# Access Compliance Report

## Public Rights-of-Way

Intersection ID: 14441	Main Street: E_KINGSTON_AV	Cross Street: SPRINGDALE_AV	Location: W
ADA ID: C2BF74A1F35D	Ramp Type: Perp	Initial Pass/Fail: Fail	Overall Compliance: No
Codes/Mitigation Info/Possible Solution			Severity Score: 25
			Field Measurements/Component Compliance

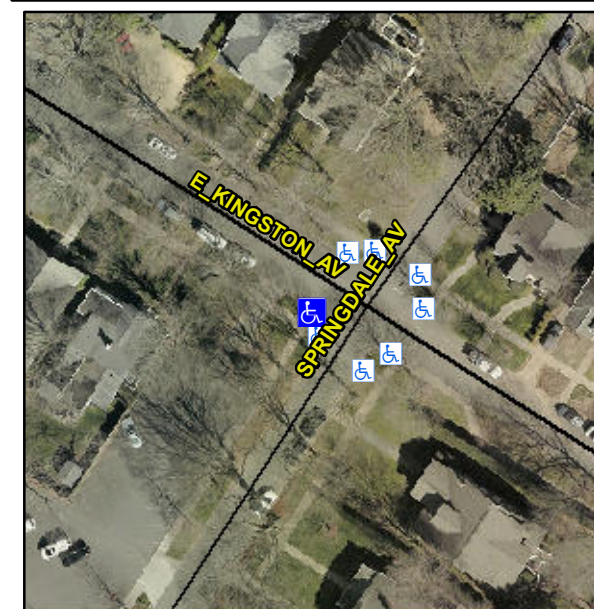
**Remove & Replace Entire Ramp.**

**Not Found, R304.2.2, R304.5.3**

Compliance	Description	Data	Compliance	Description	Data
N/A	Ramp Length (in)	80.0	No	Ramp Slope (%)	8.6
Yes	Ramp Width (in)	49.0	No	Ramp XSlope (%)	6.5
N/A	Flare Type LT	N/A	N/A	Flare Type RT	N/A
N/A	Flare Slope LT (%)	N/A	N/A	Flare Slope RT (%)	N/A
N/A	Flare Traversable LT?	N/A	N/A	Flare Traversable RT?	N/A
N/A	Landing Length (in)	N/A	N/A	DWS Provided?	N/A
N/A	Landing Width (in)	N/A	N/A	DWS Contrast?	N/A
N/A	Landing Slope (%)	N/A	N/A	DWS Length (in)	N/A
N/A	Landing X Slope (%)	N/A	N/A	DWS Full Width?	N/A
N/A	Landing Curb? (Y/N)	N/A	N/A	DWS Offset (in)	N/A
N/A	Shared Landing?	N/A			
N/A	Gutter Ponding?	N/A	N/A	Gutter Slope (%)	N/A
N/A	Gutter Lip Ht (in)	N/A	N/A	Gutter X Slope (%)	N/A
N/A	Painted X Walk1?	No	N/A	Painted X Walk2?	N/A
	X Walk 1 Direction	To NE		X Walk 2 Direction	N/A
N/A	X Walk 1 Width (in)	N/A	N/A	X Walk 2 Width (in)	N/A
	X Walk 1 Slope (%)	9.0		X Walk 2 Slope (%)	N/A
	X Walk 1 X Slope (%)	1.3		X Walk 2 X Slope (%)	N/A
